**PALM BEACH COUNTY
BOARD OF COUNTY COMMISSIONERS
AGENDA ITEM SUMMARY**

Motion and Title: Staff recommends motion to approve: Change Order No. 5 in the amount of \$171,433.30 and a retroactive time extension of 461 days to the contract dated August 25, 2020 (R2020-0992) (Contract) with J.W. Cheatham, LLC (JWC) for Lyons Road, north of Lake Worth Drainage District's (LWDD) L-14 Canal to Lake Worth Road and Lyons Road, Lake Worth Road to south of LWDD L-11 Canal (Project).

CHANGE ORDER

CHANGE ORDER NO: 5 (Five)
 COUNTY PROJECT NO: 2010504B/2007500A
 CONTRACT DATE: 8/25/2020
 RESOLUTION NO: R2020-0992
 DISTRICT NO: 6

ROADWAY PLAN

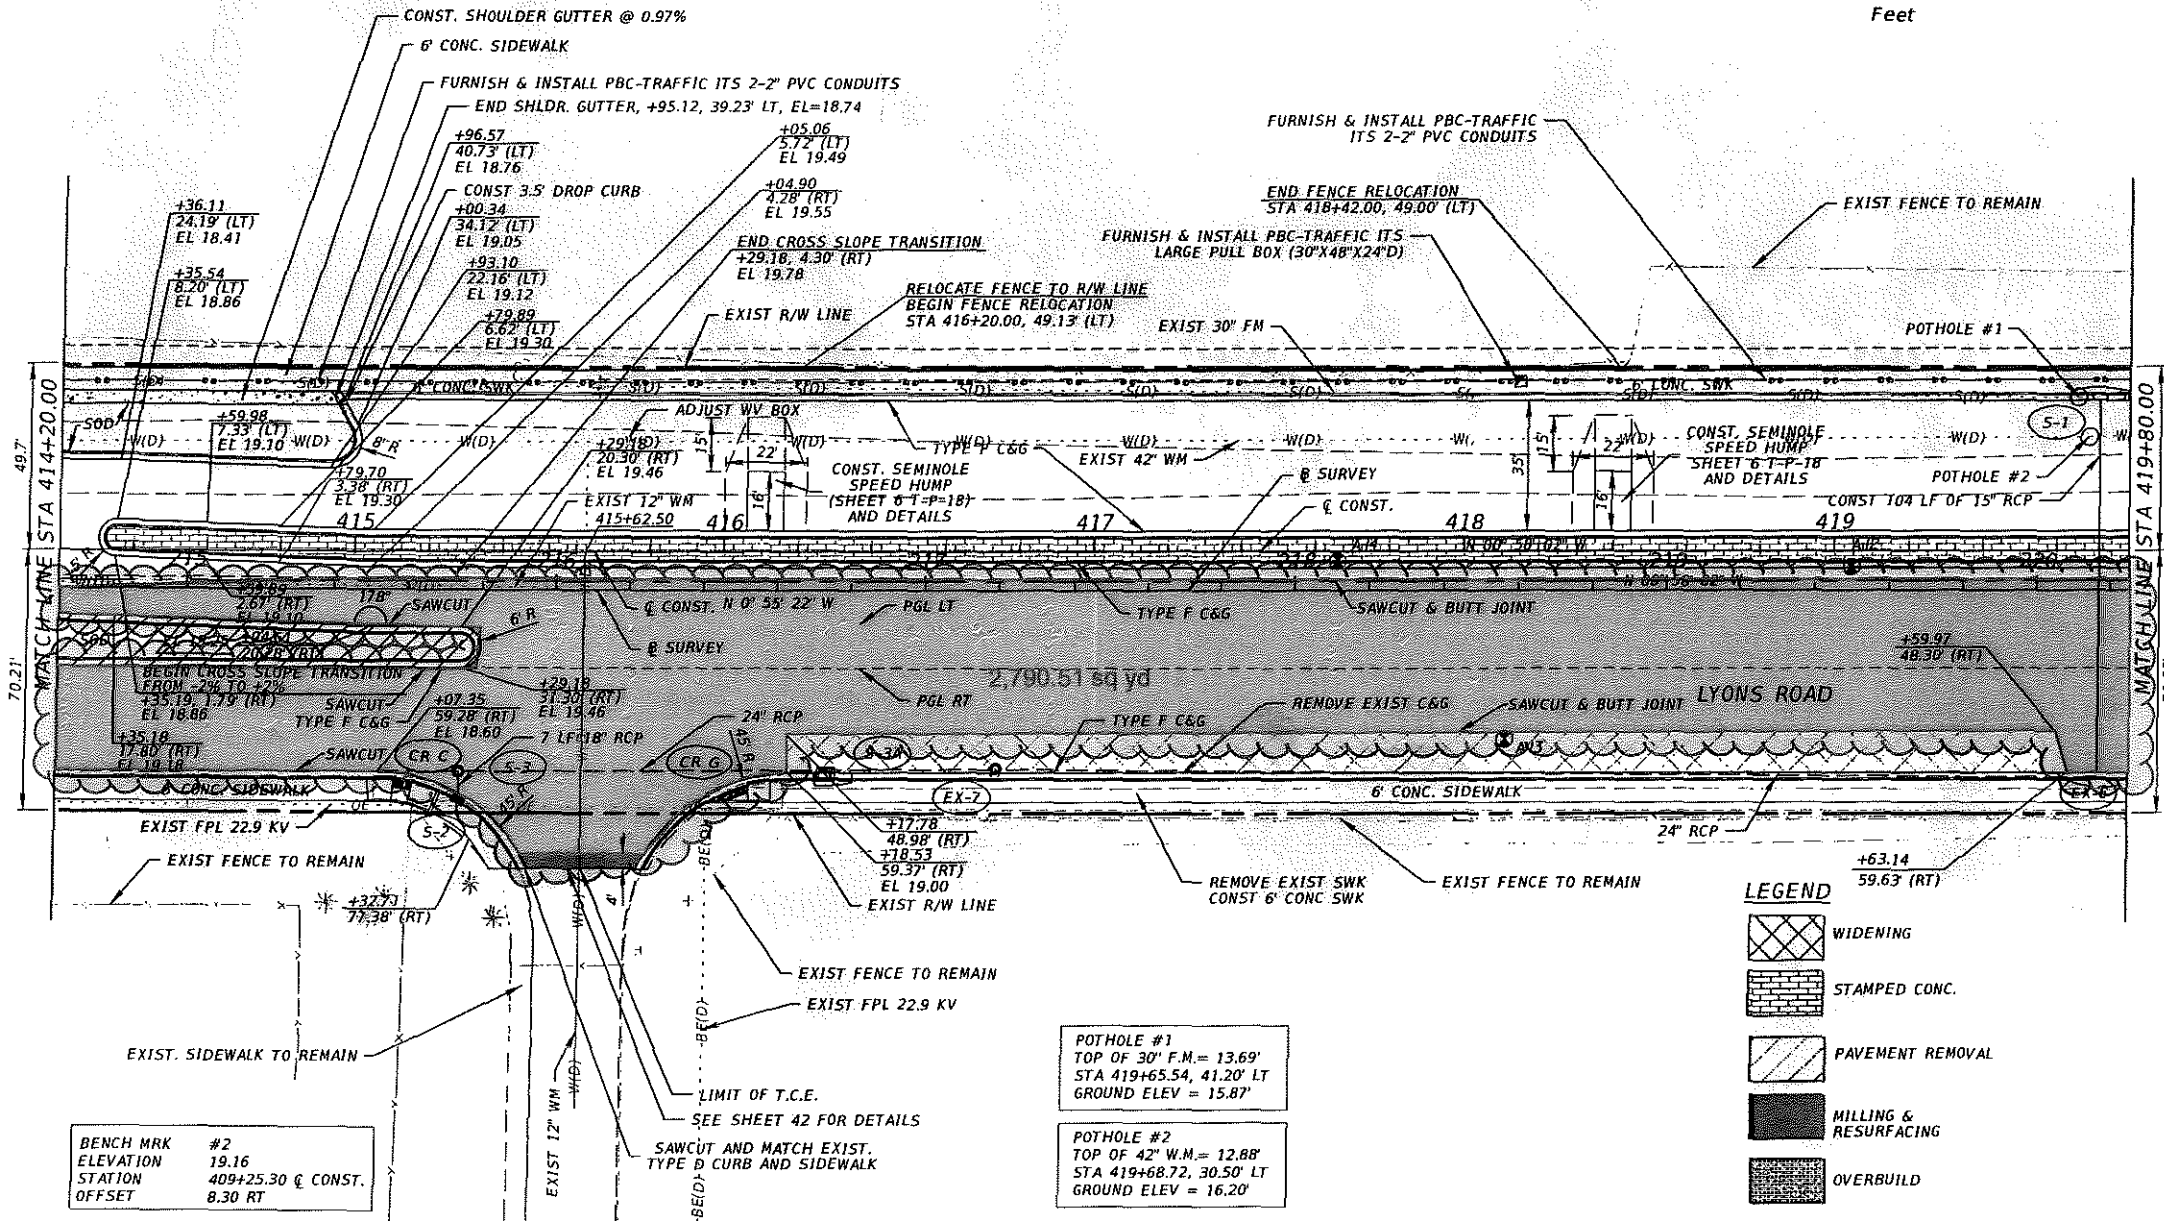
Additional Overbuild: 262.57 TN
(Most Likely due to missed
calculation on 1" milled asphalt)

Additional Overbuild per Palm
Beach County Direction: 290.47
TN

Approximately 780 SY Milling
